Bedroom 1's bathroom · design review F-05 · accept the route (A) or a private bathroom (B)? · Taif / Palm House · A ADOPTED · B NOT ADOPTED: young children's room (owner, V9.0)

OPTION A ADOPTED by the owner (2 Nov 2026): no private bathroom; the wet areas stay grouped in the two clusters; night lights along the route. 2 Nov 2026, after the stair flip (option B, F-b) · bedroom 1 is the north-east room over the maid wing, 15.75 m² on axes, 13.9 m² clear, one room without a bath · nothing in the design files changes until the owner decides · all sizes assumed

bedroom 1 · A · 1 m = 0.95 cm · north up · brown dotted = the ground floor below

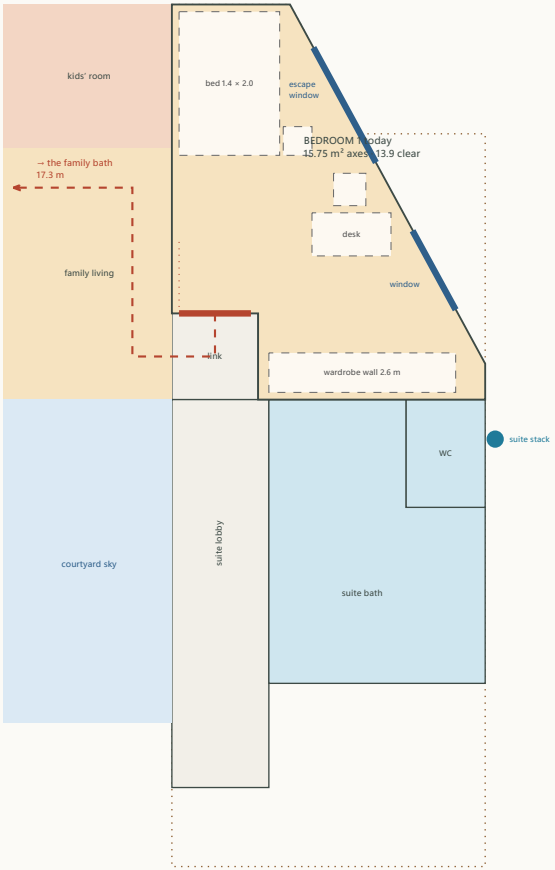
- **The walk, measured after Part 1** (the stair flipped, the family bath enlarged northwards; its door stays at x 4.25, y 9.3–10.3): bedroom 1's door → the family link → the family living, behind the sofa → the gallery's north part, past the stair arrival → the gallery → the bath's door: **17.3 m** (the same as before the flip: the bath grew, its door did not move). Five spaces, two of them lived in (the living, the gallery).

- **Who shares the family bath:** bedroom 1 (17.3 m), bedroom 2 (2.7 m), the kids' room and the family living (a bedroom later); bedroom 3 and the suite have their own. Since F-b it has **two compartments** (a WC by the shaft and the shower + double basin), so two children at once.

- **Comfort:** a child or a guest in bedroom 1 crosses the **family living** at night and in the morning, in sight of whoever is there; 17 m is the longest bathroom walk in the house (the suite's is 0, bedroom 3's 2.7, bedroom 2's 2.7).

bedroom 1 · B2 · 1 m = 0.95 cm · north up · brown dotted = the ground floor below

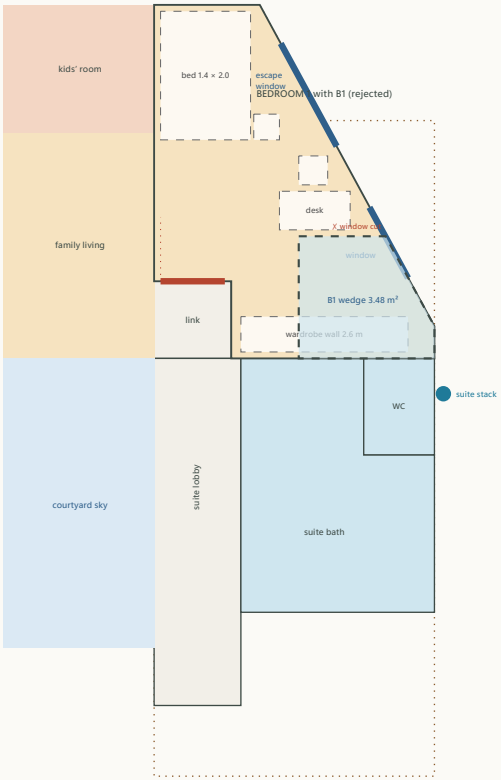
- **B2 (the best, drawn):** a bath along bedroom 1's **south wall**, x 10.6–13.311, y 5.0–6.5, its east end following the cut wall: **3.79 m² on axes, 2.49 × 1.3 clear less the slant ≈ 3.0 m²**: a walk-in shower 0.9 × 1.2 at the east end (its corner 0.02 m west of the cut wall), the WC in the middle facing north, the basin on the west wall, a **sliding 1.0 m door** from the room (no swing), a **small window on the cut wall** (y 5.35–5.85, sill +1.60, obscured). It is **next to the master suite's wet stack**: the pipes run 2.5 m east in the bath's own floor zone to the suite's stack outside the east wall (y 7.05), **over the GF maid room only** (the kitchen and its hood zone start at y 7.0; nothing over the master bedroom).

- **Bedroom 1 with B2: 11.96 m² on axes, ≈ 10.3 m² clear** (was 15.75 / 13.9): the bed 1.4 × 2.0 stays on the west wall with its bedside table, the desk and chair under the escape window, the wardrobe wall (2.6 m) becomes **two wardrobes, 1.3 m on the bath's wall and 0.9 m on the west wall** (2.2 m in all); the door's swing stays clear; the **escape window stays the room's** (the fire study unchanged); the second window (y 4.15–5.25) lights the desk. Still a full bedroom (a 1.4 bed, a desk, 2.2 m of wardrobe), no longer a two-bed room.

- **Drain:** the shower, the WC and the basin to one branch running east along the bath's south side to the **suite's stack** outside the east wall (y 7.05), 2.5 m; the branch crosses the room's south wall line at x 13.311 and turns south outside the wall for 0.6 m (or a second stack beside the suite's; the MEP engineer). **Over the GF maid room only**: not over the kitchen (y ≥ 7.0), its hood zone (the east wall y 10.2–11.2) or the master bedroom (x 8.95–13.311, y 11.9–19.25).

- **Structure (`studies/structure.typ`):** the maid wing's first-floor bay is a **solid 0.20 slab** spanning east–west 4.36 m to the cut wall; a 0.15 depressed zone cannot be cut from 0.20. Two ways, the engineer's choice: **(i)** cast the bay 0.35 thick under the bath with its top depressed 0.15 (as the suite bath, X10), or **(ii)** keep the slab and run the pipes **below** it in the maid room's ceiling void (the maid room gets a gypsum ceiling anyway; 3.1 m clear left) with a wall-hung WC and a shower tray raised ≈ 0.10. The bath's walls are light partitions on the slab (no beam; B6 at y 6.5 is the room's south wall beam, untouched).

- **Windows:** the bath's small window on the cut wall faces the lane side (obscured glass, a vent); the room keeps both its windows. **Ventilation:** the window plus an extract fan to the roof riser is not available here: an extract through the cut wall (a small louvre) or a duct in the ceiling void to the east wall.

Recommendation: B2, if bedroom 1 is to be a guest room or an older child's room; otherwise A

bedroom 1 · B1 · 1 m = 0.95 cm · north up · brown dotted = the ground floor below

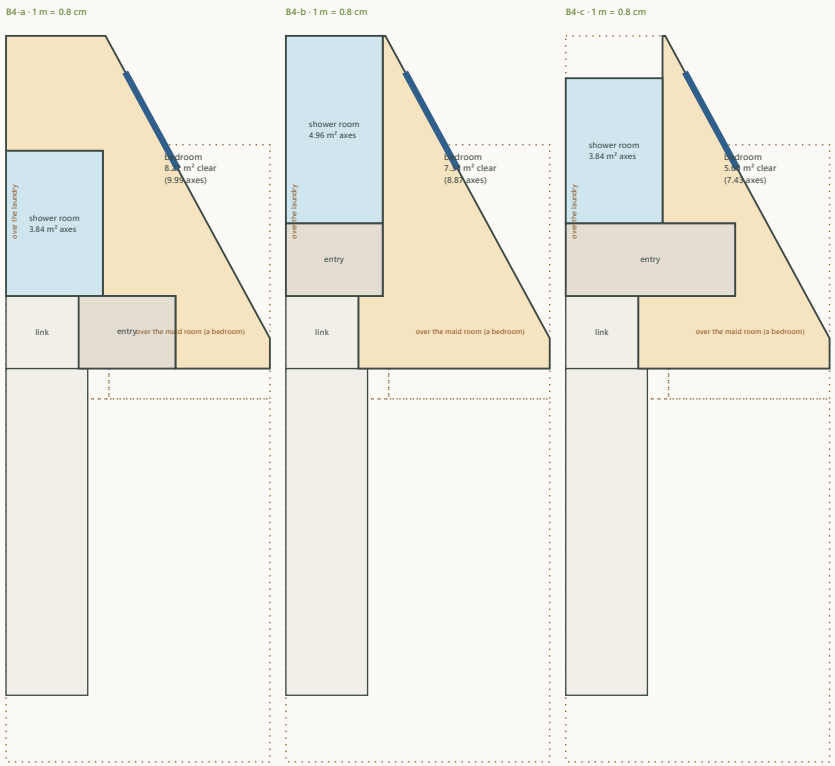
- **B1 (the south-east wedge, dashed on page 2):** x 11.2–13.311 on the cut wall, 3.48 m²: a wedge, its north wall cuts the second window (y 4.15–5.25) and leaves 0.8 m of the wardrobe wall: worse than B2 for the same plumbing. **B3 (the north-east corner):** the north-east corner (x 10.6–12.0, y 1.0–2.9) holds the room's **escape window** and the bed's head wall: a bath there moves the escape window and the bed; rejected without drawing.
